ADDENDUM 1

To the Contract Documents for the New TK Modular Addition & Site Work

Terrace View Elementary School
Colton Joint Unified School District
Bid Number: 26-014FAC
SGH Architects Project Number: 22-12107-00
DSA A#04-124750

OVERALL SITE PLAN
1" = 40'-0" SCALE

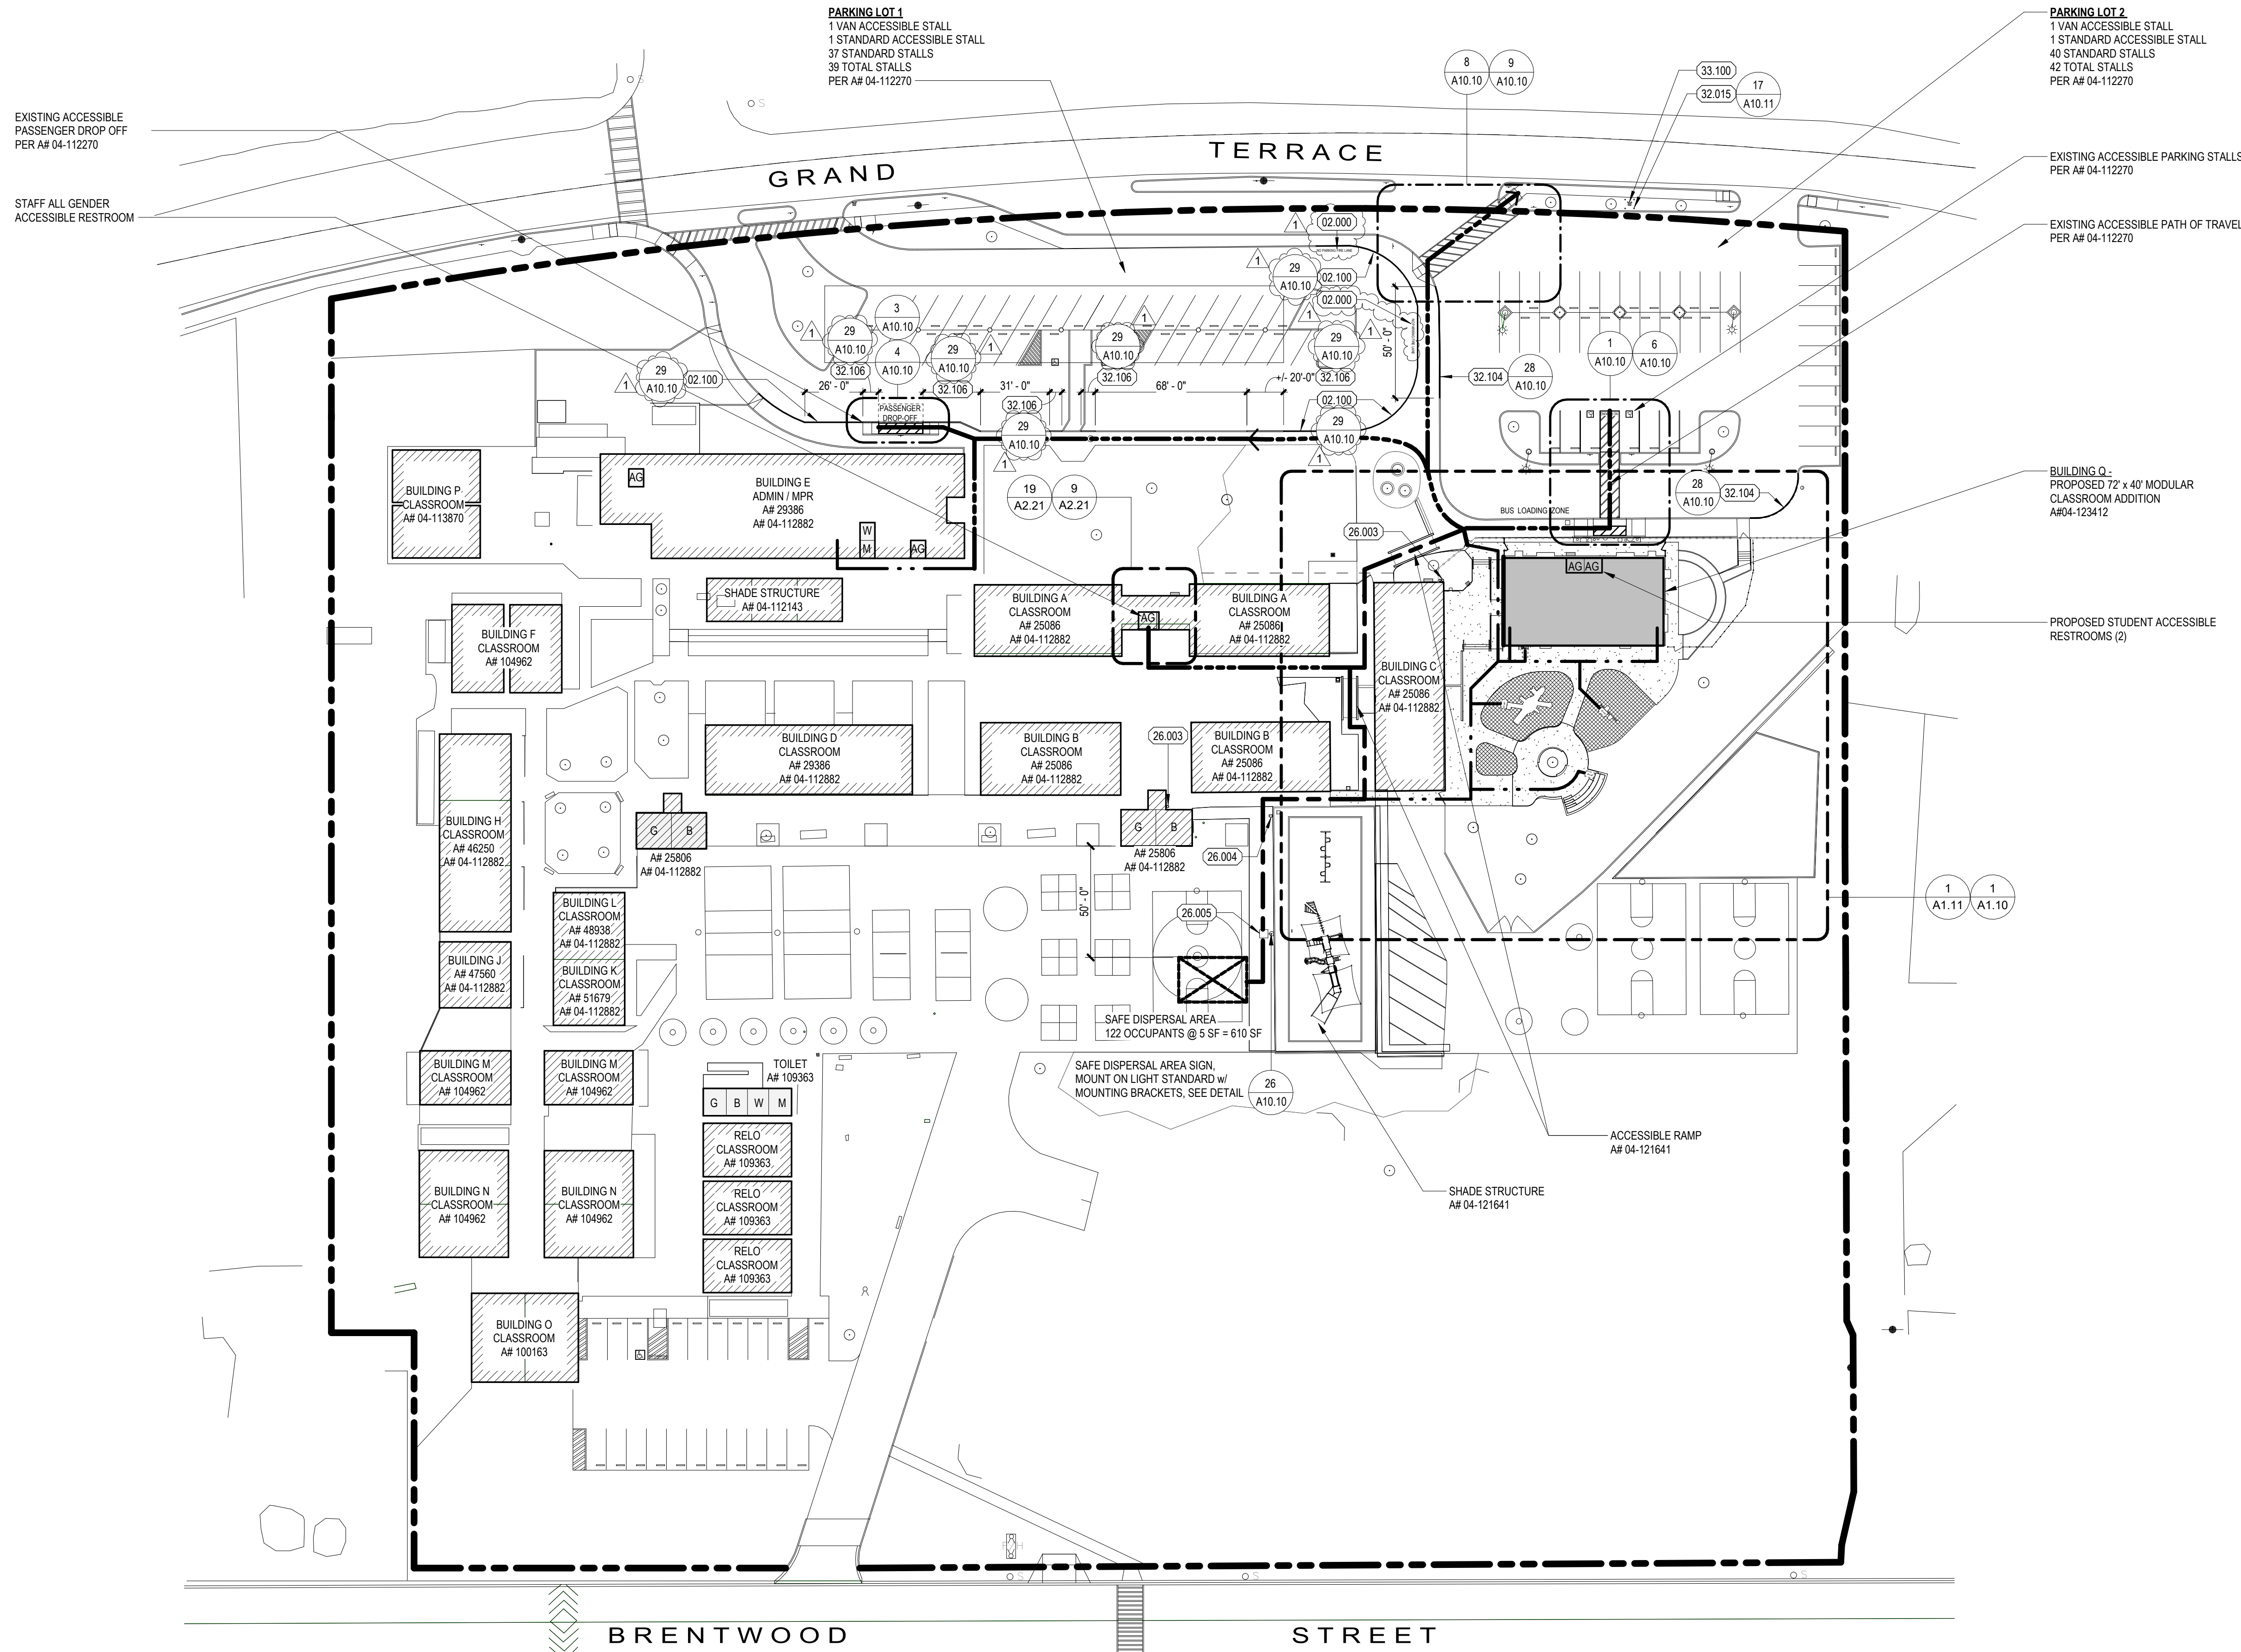
- B. Sheet A1.01 – Overall Site Plan (Attachment 7)
 - a. Added Keynote #02.000 to remove existing paving markings and paint them black at (2) locations near the existing driveway curb at the North/East corner of parking lot A on the Overall Site Plan detail 1.

- b. In keynote #02.100, the word “PAINT” was changed to “RE-PAINT”.
 - c. In keynote #32.106, the word “EXISTING” was added in front of “CURB”.
 - d. Added the Detail reference 29/A10.10 at all keynotes 02.000 and 32.106 on the Overall Site Plan Detail 1.

REMODEL PLAN - BUILDING A EXISTING RESTROOMS
1/4" = 1'-0" SCALE

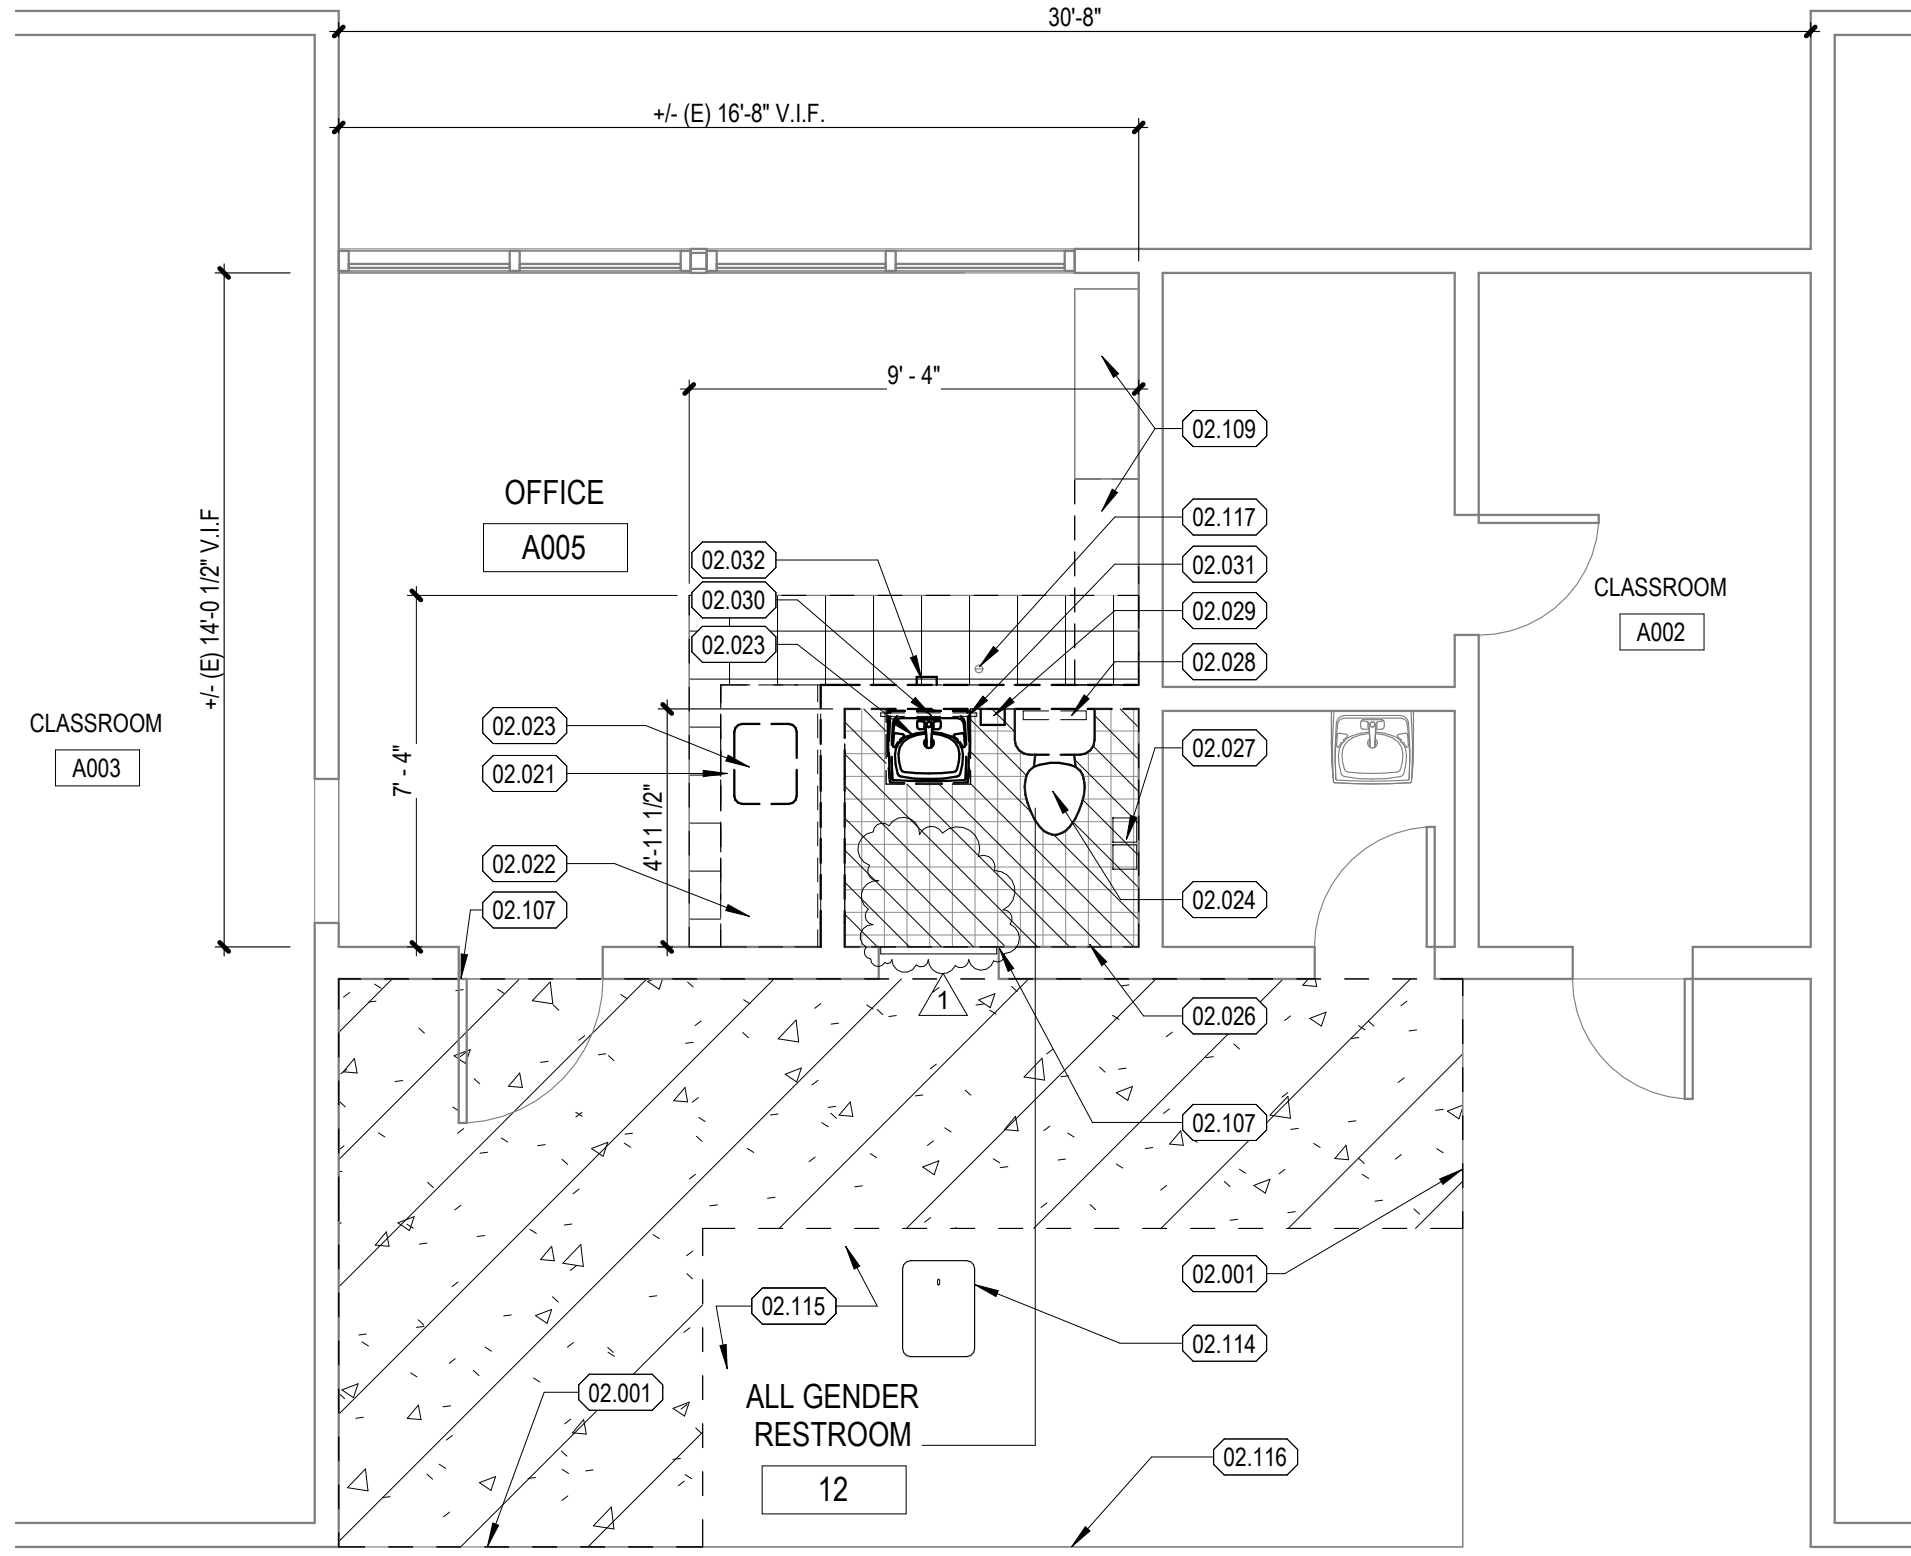
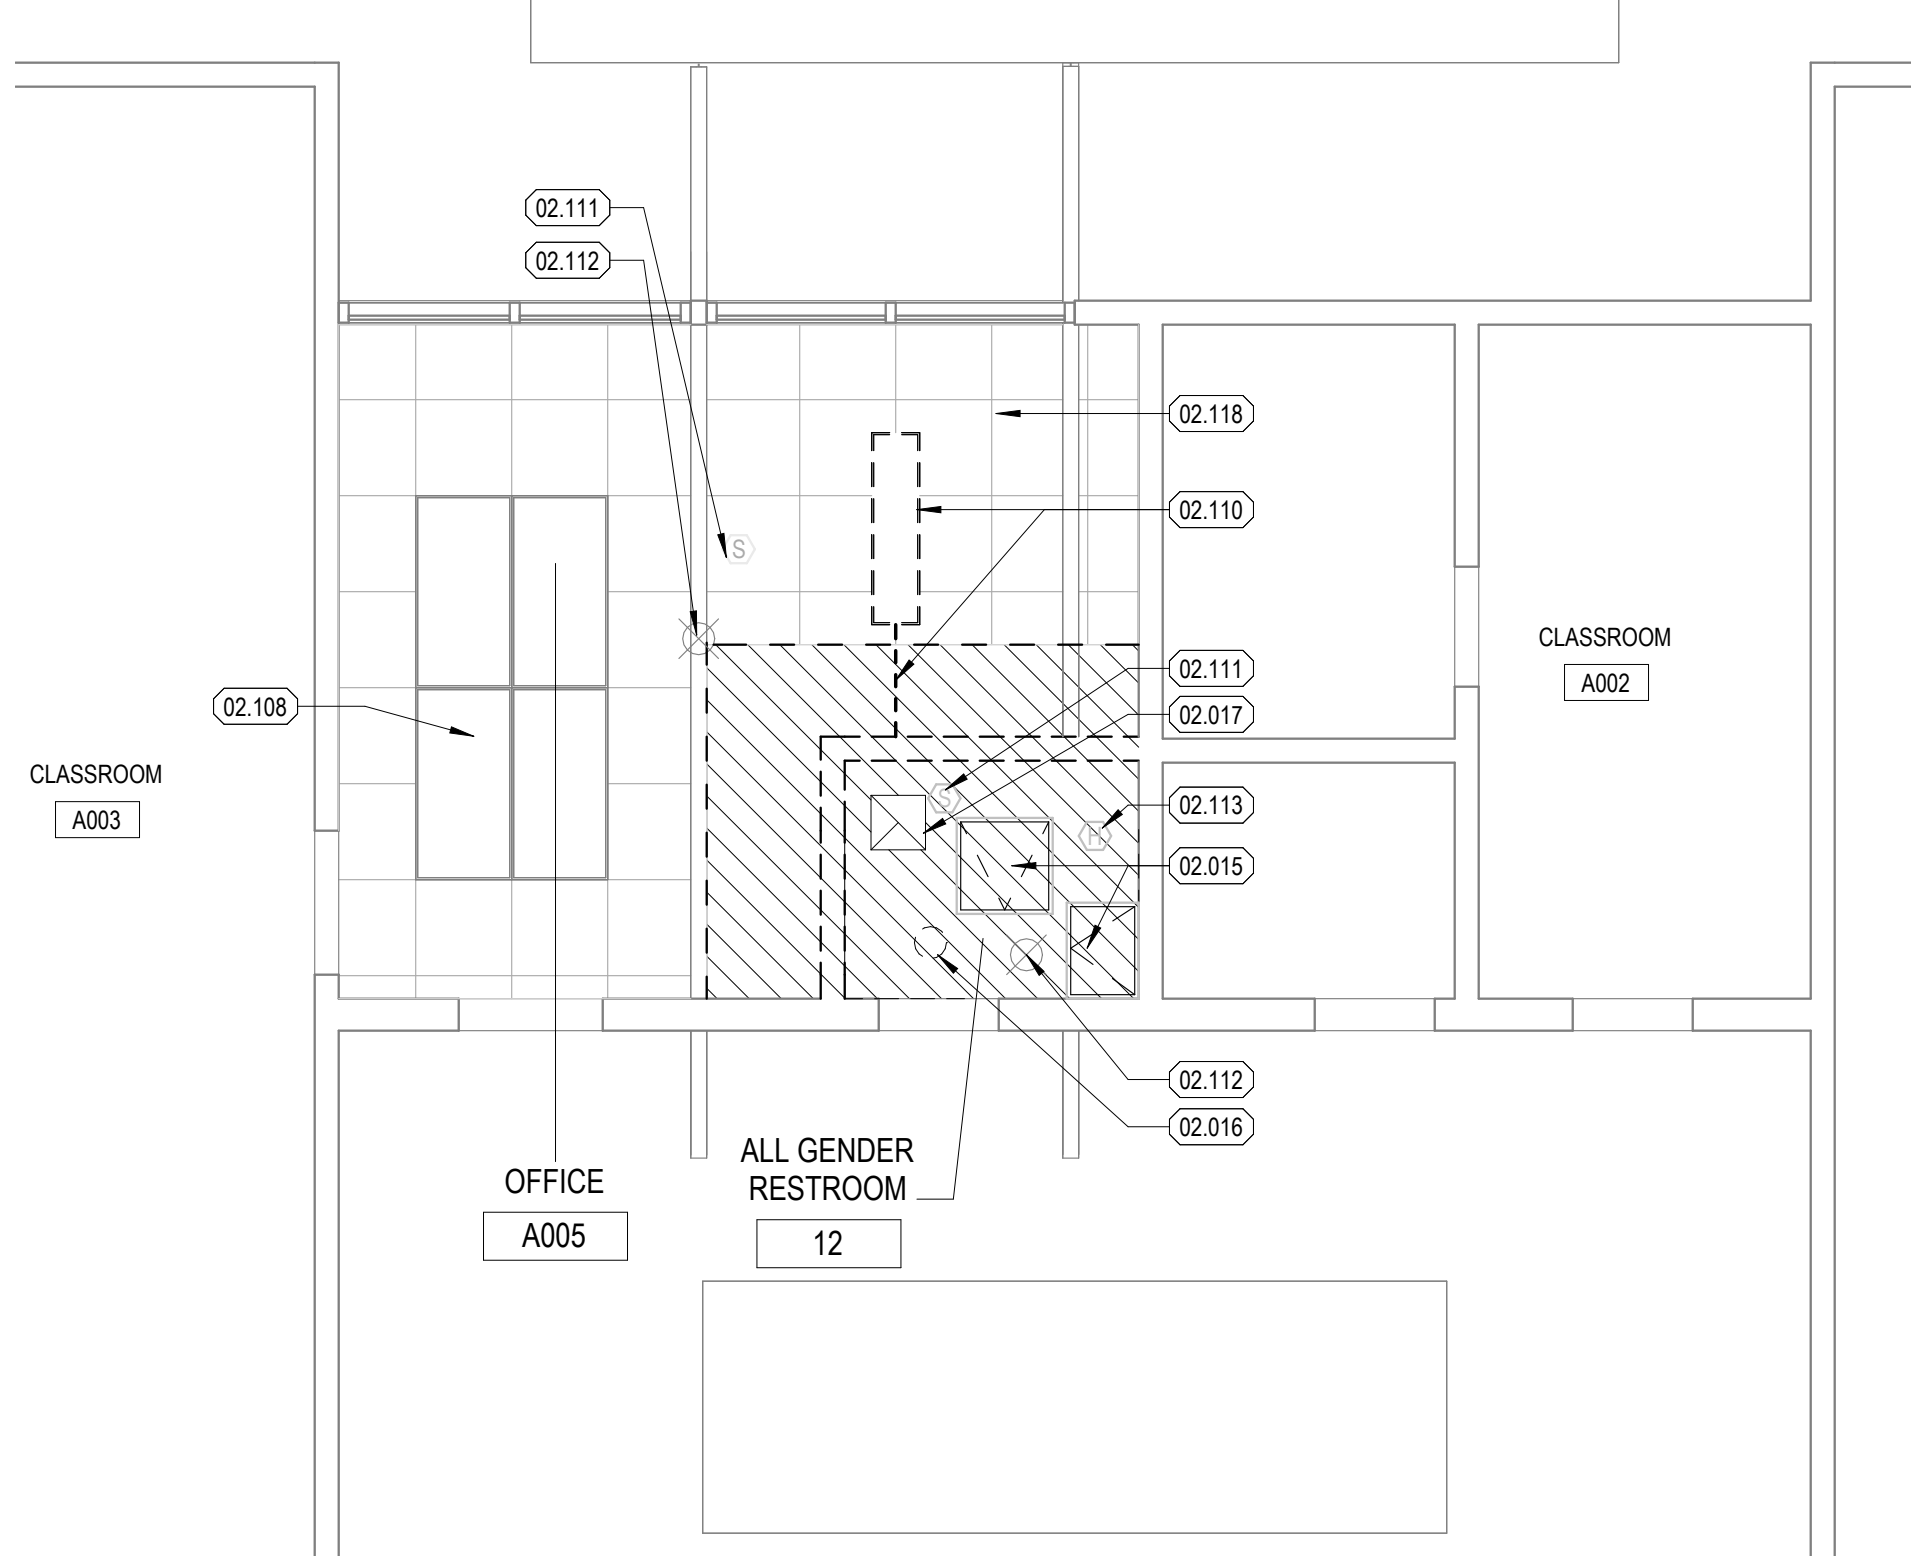
- C. Sheet A2.21 – Staff Restroom Plans, Sections and Elevations (Attachment 8)
 - a. At the Staff Toilet, revised existing door to show in closed position on Demolition Plan – Building A Existing Restrooms Detail 9.

- b. At the All Gender Restroom #12, revised existing door #23 to show in closed position, removed door/room signage and door clearances on Remodel Plan – Building A Existing Restrooms Detail 19.

- c. On the Door Schedule, at door #23 under Comments, added a note to render the door inoperable per Detail 14/A10.51.
- D. Sheet A10.01 – Details – Modular Building Floor Plans and Signage (Attachment 9)
